From: Gulmohar Residency <info@modiproperties.com>
Sent: 30 May 2023 12:54
To: cr@modiproperties.com; feedback@modiproperties.com;
kprasad@modiproperties.com; gbrambabu@modiproperties.com;
gmr@modiproperties.com; sateeshksurya@gmail.com
Subject: Complaints And Suggestions from Gulmohar Residency

Complaint Id : 7846
Project Name : Gulmohar Residency
Block No / Phase : Block G
Flat No/Villa :304
Nature of complaint :Construction
Customer Name : Sateesh Kumar Surya
Email : sateeshksurya@gmail.com
Complaints :
1. Doors lock problem
2. Broken tiles

Quality Control Check Report.				Stage: After Finishing Stage III (Apartments)	
Flat No	G-304	Other		Sl. No.	42690
Company	MRM-CLLP	Project		Phase	
Prepared by	P. Bhazath	Sign	GMR	Date	23-12-23
Project Manager	Nazendar	Sign		Date	23-12-23
Previous stage report no.					
Checked By MD on		41737	Report filed and signed by PM		☒ Yes ☐ No
Recommendation:		MD Sign		For filling	☐ Yes ☐ No
☐ Stop further work. Submit ATR on QC report to QC team. Proceed only after recheck by QC. ☒ Stop further work. Proceed with work after submitting ATR on QC report to QC team. ☐ Proceed with further work only after making corrections pointed out in the QC report.

ELECTRICAL PLAN - 1360 sq ft FLATS-A1 TYPE	Description	Owners & Developers	Date	Prepared By	21.08.2020	Approved By	Project Name & Phase	Scale	Drawn By	Checked By	Reviewed By
		Modi Reality Mallapur LLP		Jayaprakha		Saham Meshi	Gulmohar Residency				
						N T S

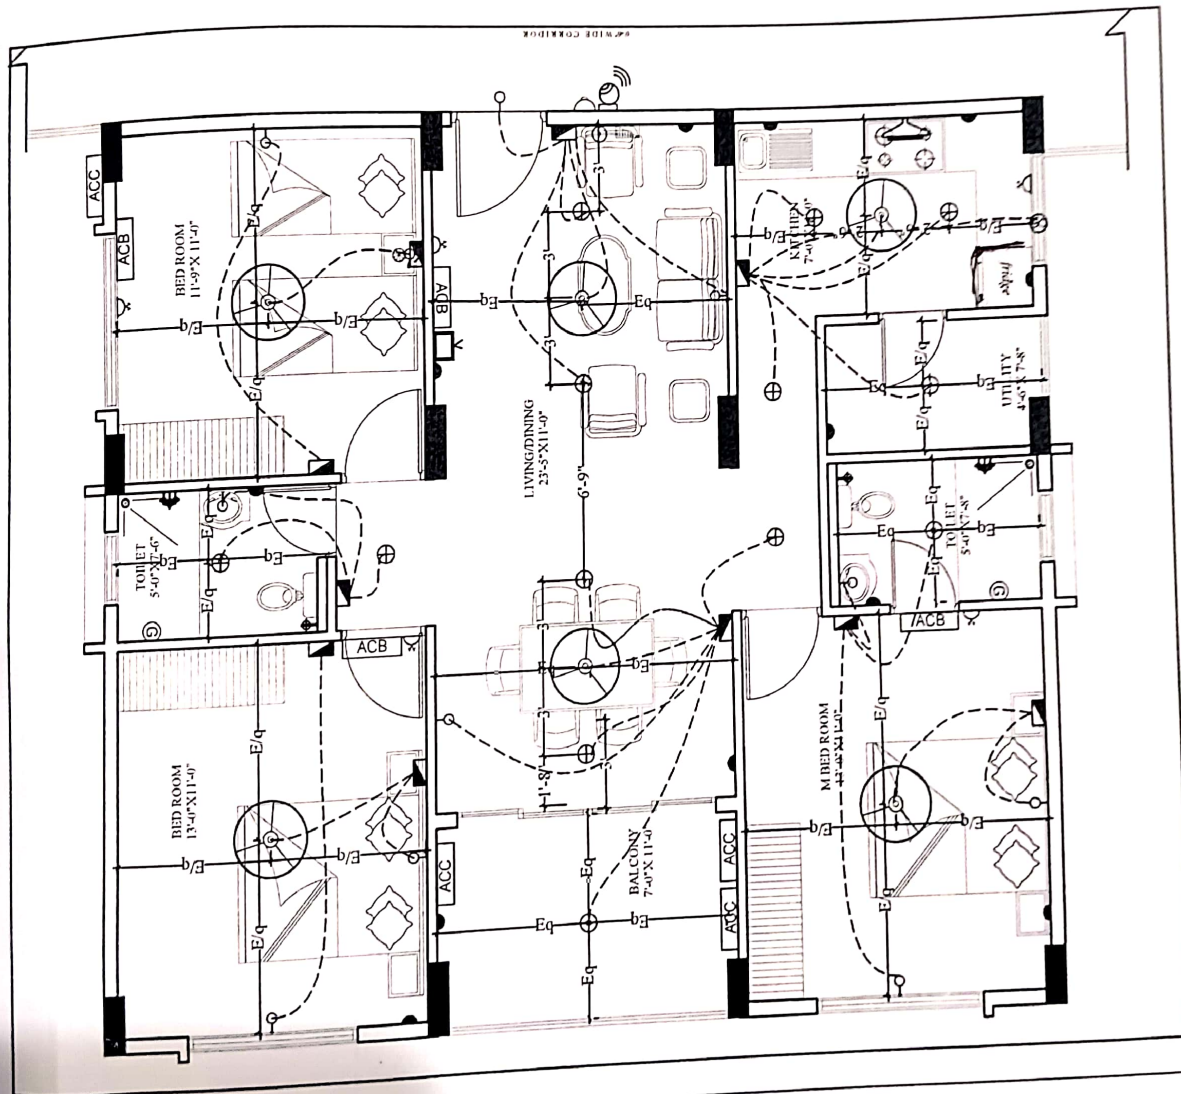
1) wash basin @ Balcony - 13/5/23.

2) * Living & all rooms fan point not in center -

3) Bed room h/c should be replaced.
